TECHNICAL REVIEW GROUP

A SUGGESTED CONTROL MEASURE FOR  
CONTROL OF ETHANOL EMISSIONS FROM WINERY  
FERMENTATION TANKS

TECHNICAL SUPPORT DOCUMENT

Approved by the Technical Review Group on October 7, 1986

FIGURE VI-1  
FIFTEEN TANKS EXHAUSTED TO  
EMISSION CONTROL DEVICE\*

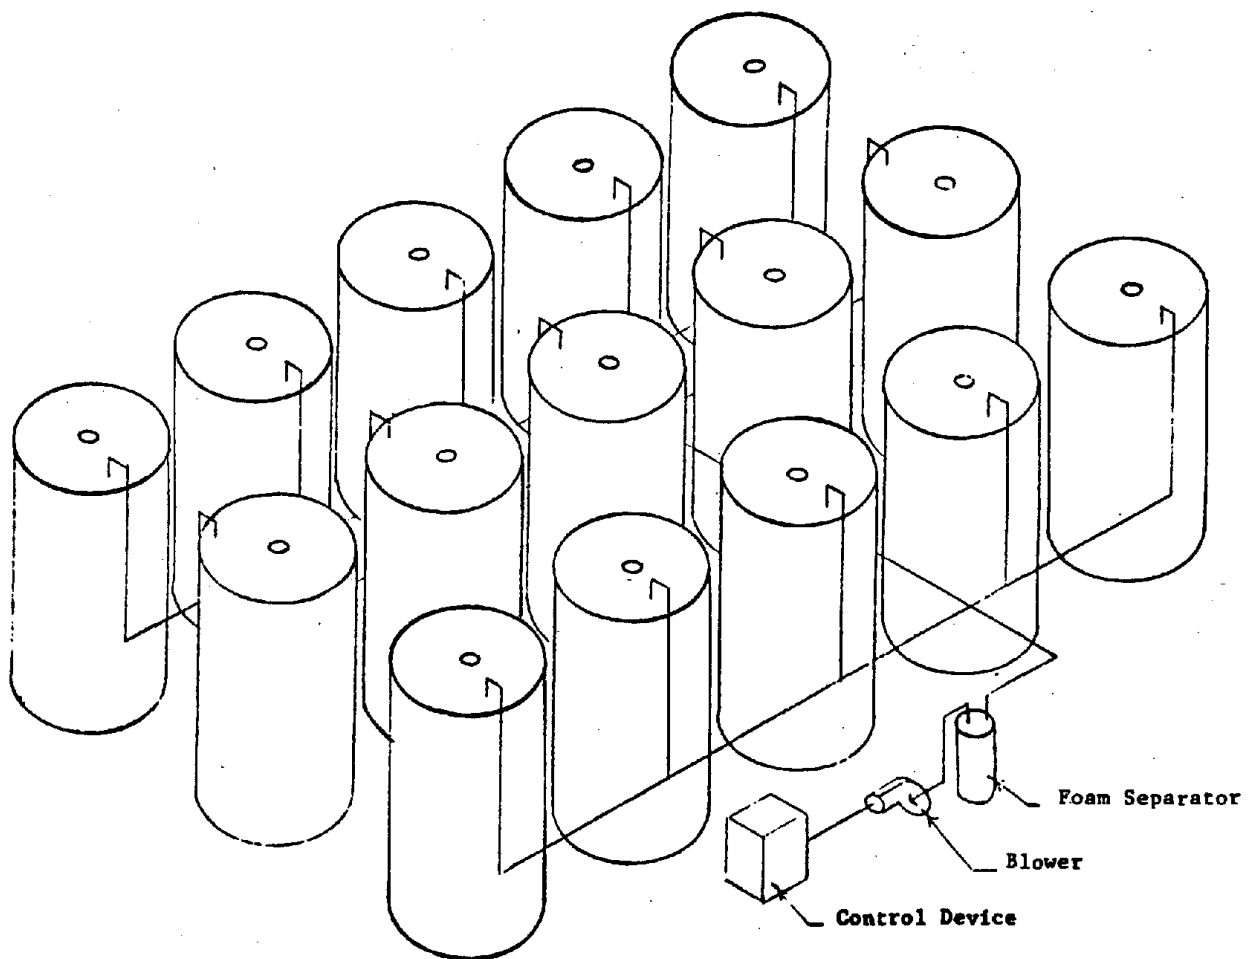
6. COMMENT: The tank layout at many wineries is far from the simplified model depicted in the ARB drawings. At some wineries, tanks are spread over a relatively wide area. This would dramatically increase the cost of the ducting system at those wineries.

RESPONSE: The staff estimate is of necessity based on a simplified layout. Because of differences between wineries, it is not possible for the staff to make detailed estimates for particular wineries. In practice, wineries would group their tanks into tank farms based on the most economical combinations. In reality, some tanks may be farther apart and others closer together than assumed by the staff. The staff believes that its cost estimates are representative of potential winery costs.

FIGURE VI-2  
SCHEMATIC OF POSSIBLE CONNECTION  
OF DUCTING AT TANK

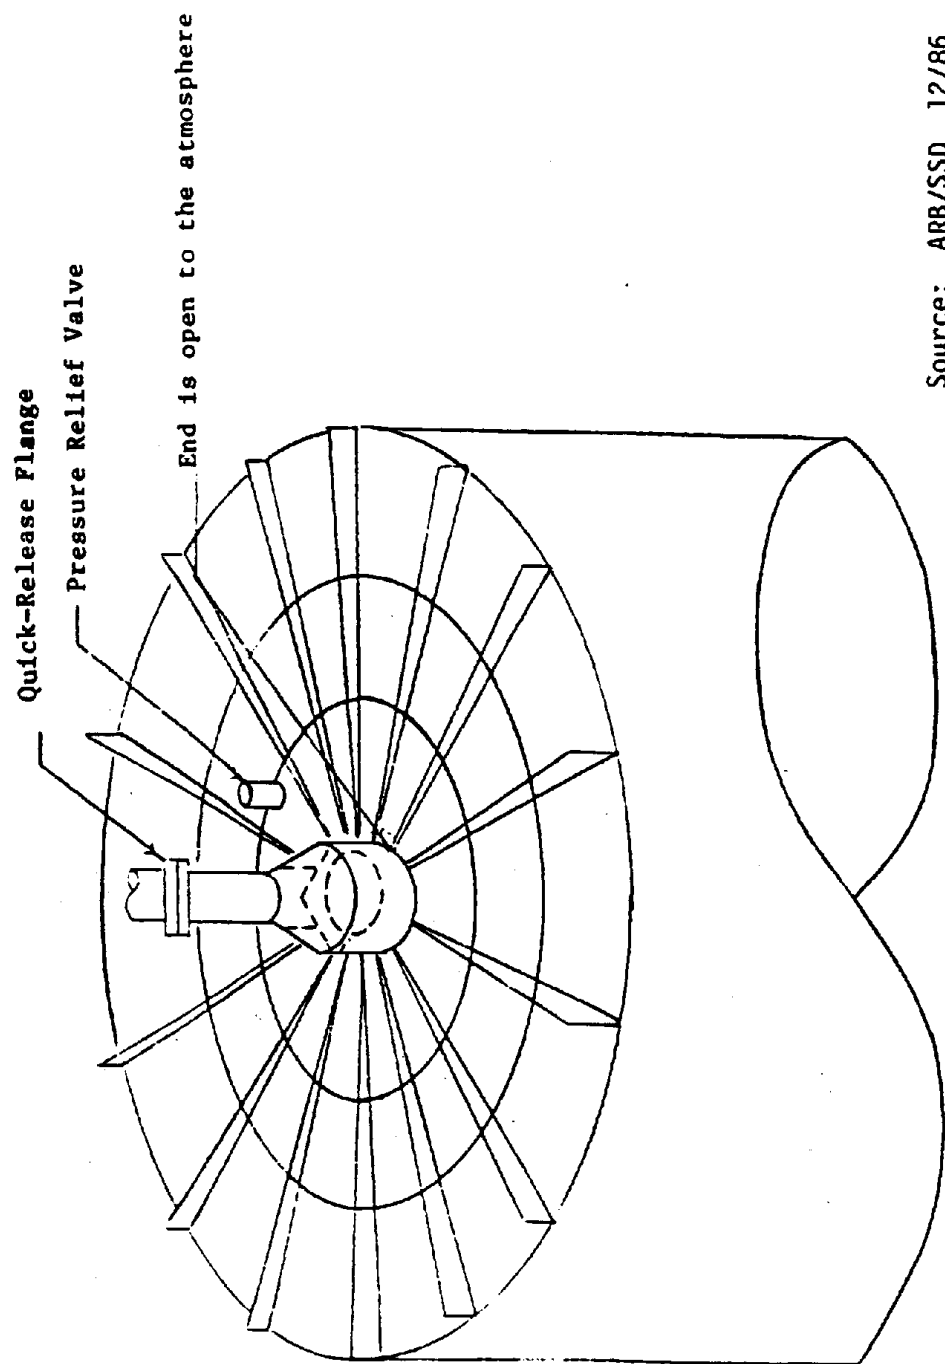
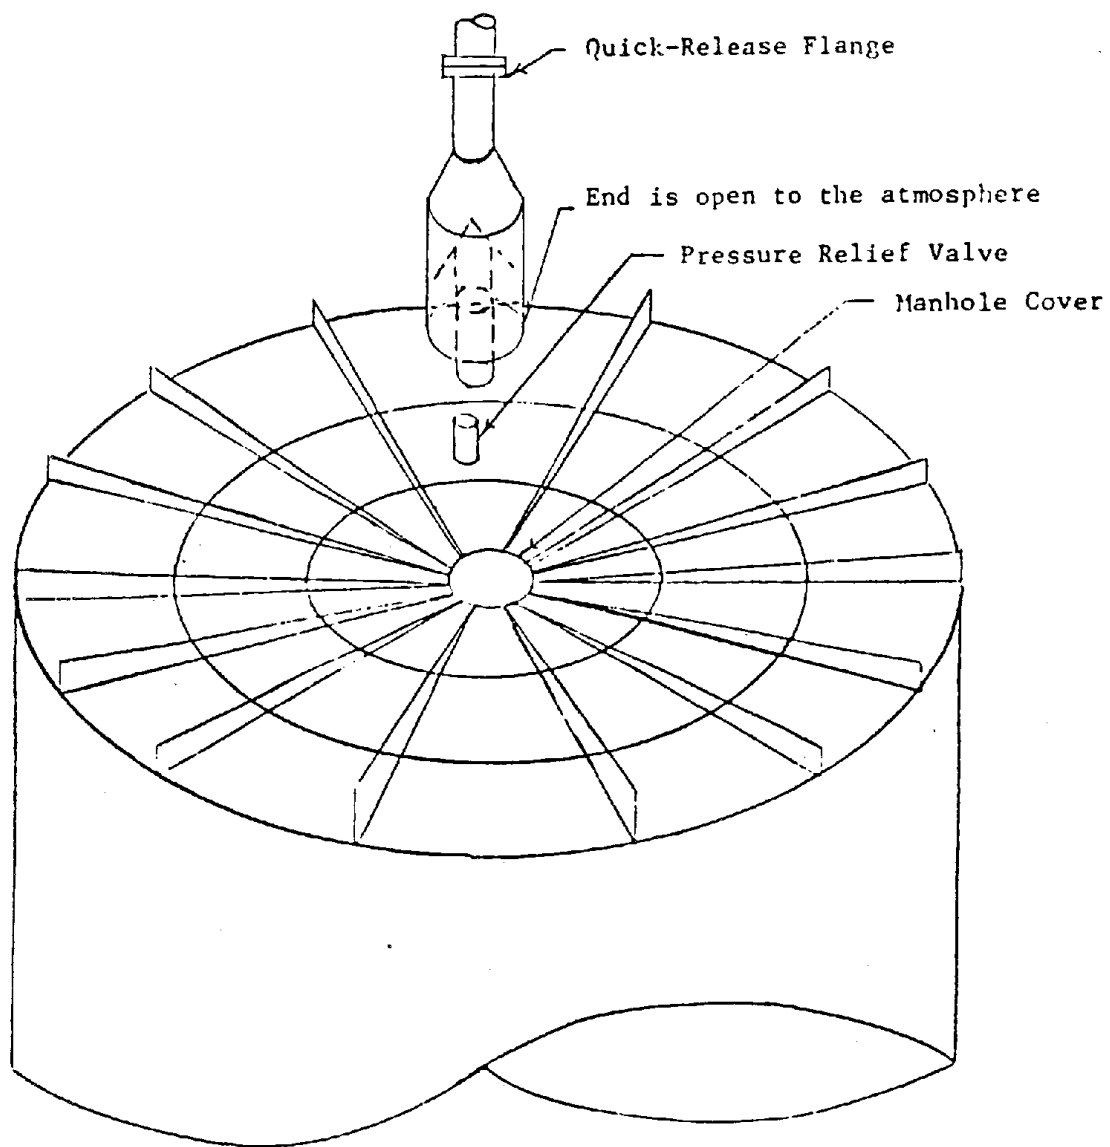
4. COMMENT: The "staff report" does not provide design details for the ductwork connection to the tank. A detailed schematic should be included before we can comment.

RESPONSE: A schematic, included in Chapter V of this staff report, was provided at the April 22 meeting. It is inappropriate for the staff to make detailed design of pollution control equipment. This is the responsibility of the individual winery. Qualified engineers should be employed to provide detailed equipment design.

FIGURE VI-4  
SCHEMATIC OF CARBON ADSORPTION SYSTEM

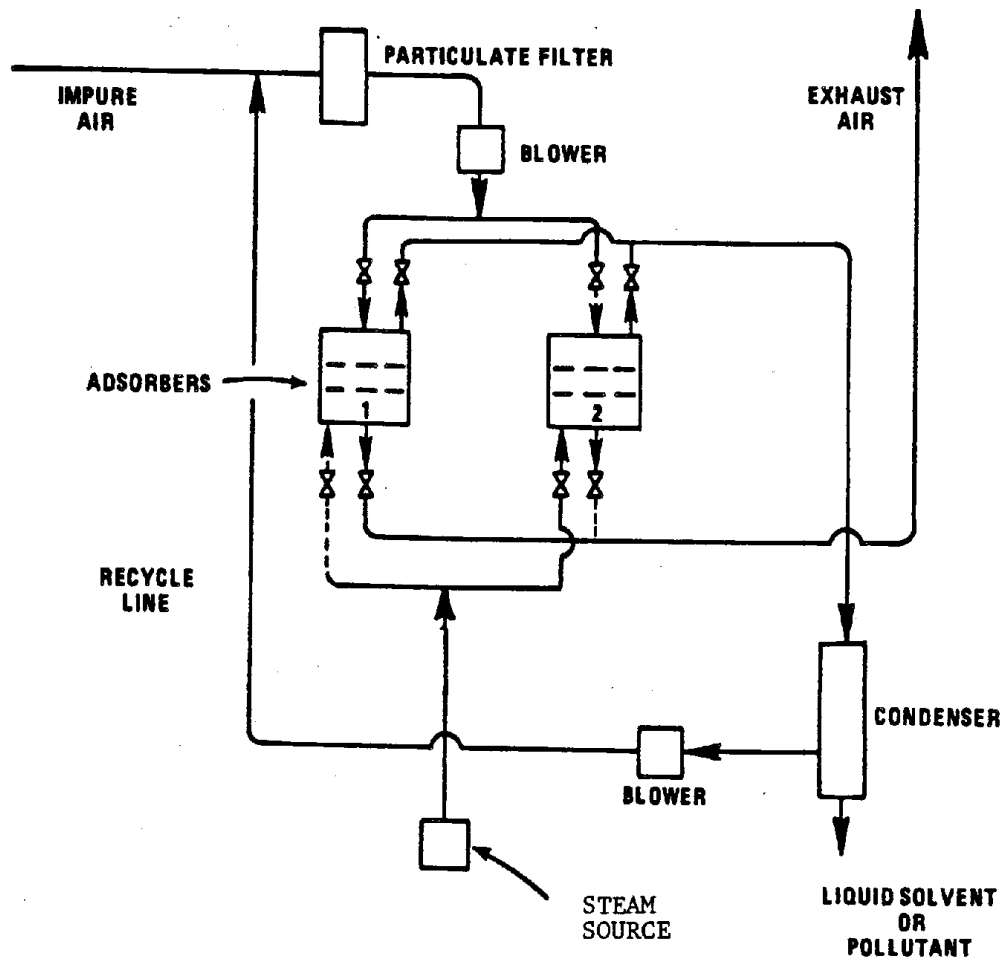
14. Pages 29-31, design of carbon adsorption system and Figure V-4:

The staff describes how carbon adsorption works in theory, but fails to describe the equipment used in a carbon adsorption system. Figure V-4 is only a diagram of how the pieces of equipment in such a system might relate to each other. The figure provides no information on the design of the equipment. Given this deficiency, which the staff has known about for some time (May Comments, p. 21), Wine Institute can neither determine whether the equipment will achieve the required 90% control efficiency nor evaluate the accuracy of the specific cost estimates made by the staff.

Wine Institute believes that carbon adsorption is generally used for removal of aromatic and nonpolar gases like solvents from emissions streams (see Exhibit 1, an excerpt from a supplier's technical information sheet). Ethanol is both aliphatic and polar, so that information gained from typical applications of carbon adsorption is not transferable to ethanol emissions.

FIGURE VI-5  
SCHEMATIC OF CATALYTIC INCINERATOR

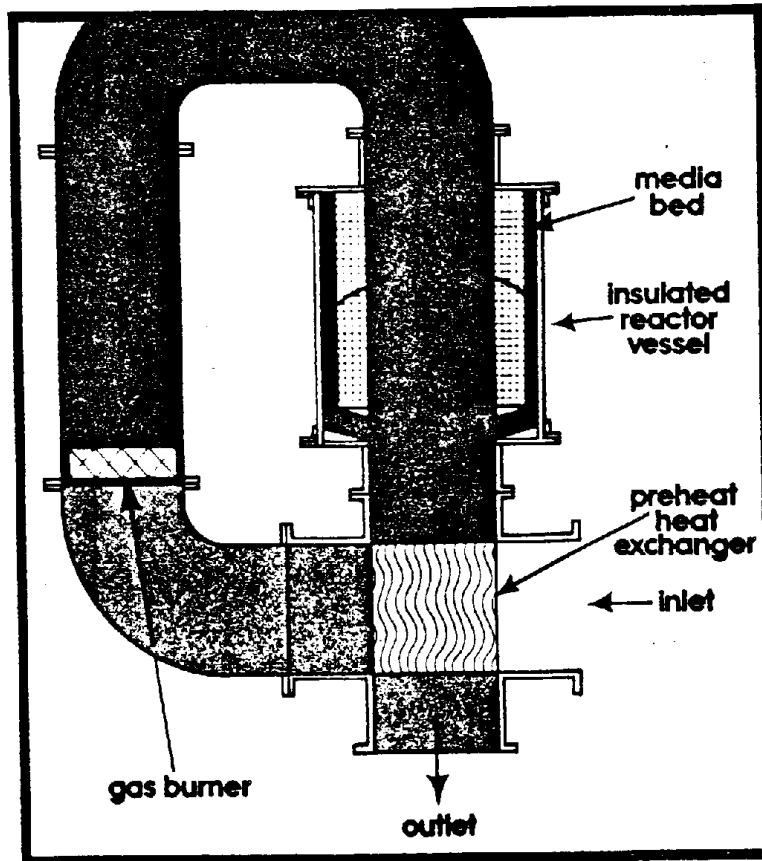
16. Pages 33-35, design of catalytic incineration system and Figure V-5:

FIGURE VI-6  
SCHEMATIC OF PACKED-TOWER SCRUBBER

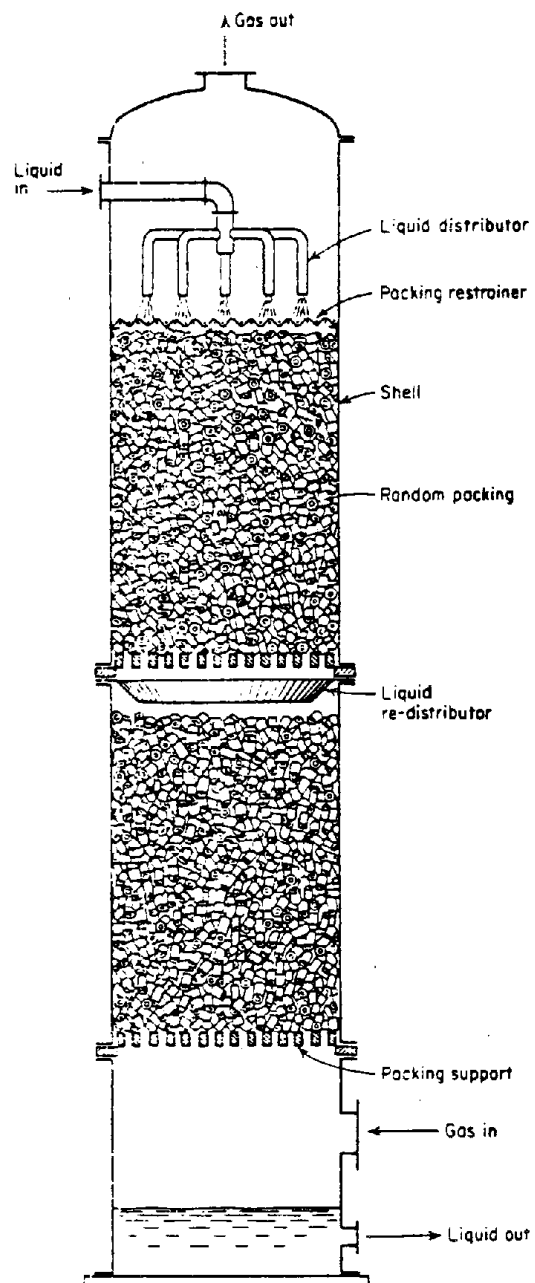
17. Pages 34, 36-37, design of scrubbing system and Figure V-6:

While the staff has provided an example of a scrubbing unit in Figure V-6, it is not clear whether the cost quotes set forth on page A-47 are for the scrubber shown or for some other system. In any event, the sizing and efficiency of any scrubbing unit are issues that would have to be resolved in a pilot study.

FIGURE C-1  
EXPANDED VIEW OF TANK OPENING \*

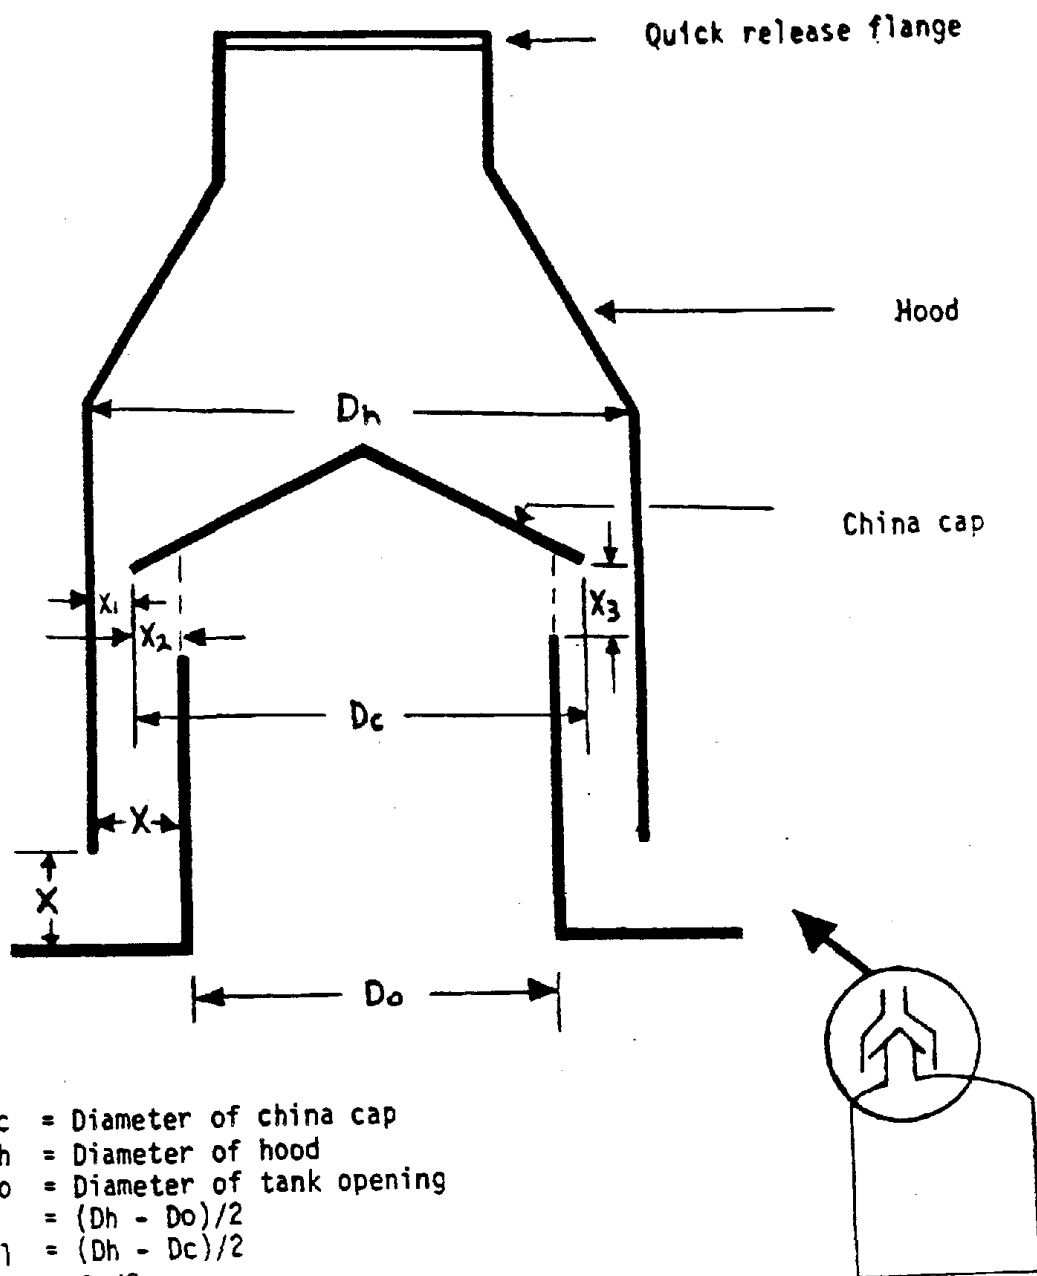
9. COMMENT: With an assumed airspeed of 34 miles per hour, the manifold will pick up large quantities of entrained sugar, dust, and insects from the air and any foam that the tank produces. Additionally, the airspeed required by the proposed design would disturb vapor pressure which would increase ethanol emissions. This could also remove flavor and aroma components from the wine.

RESPONSE: The airspeed of the fermentation gases entering the exhaust hood is not 34 miles per hour, but only seven miles per hour (approximately 10 feet per second; see Appendix C). An airspeed of 34 miles per hour is only attained once the exhaust gases bypass the hood and china cap and enter the smaller diameter ducting. The staff has calculated the diameter of the hood necessary to insure a sufficiently low airspeed so as not to disturb the vapor pressure within the tank. These calculations are presented in Appendix C.
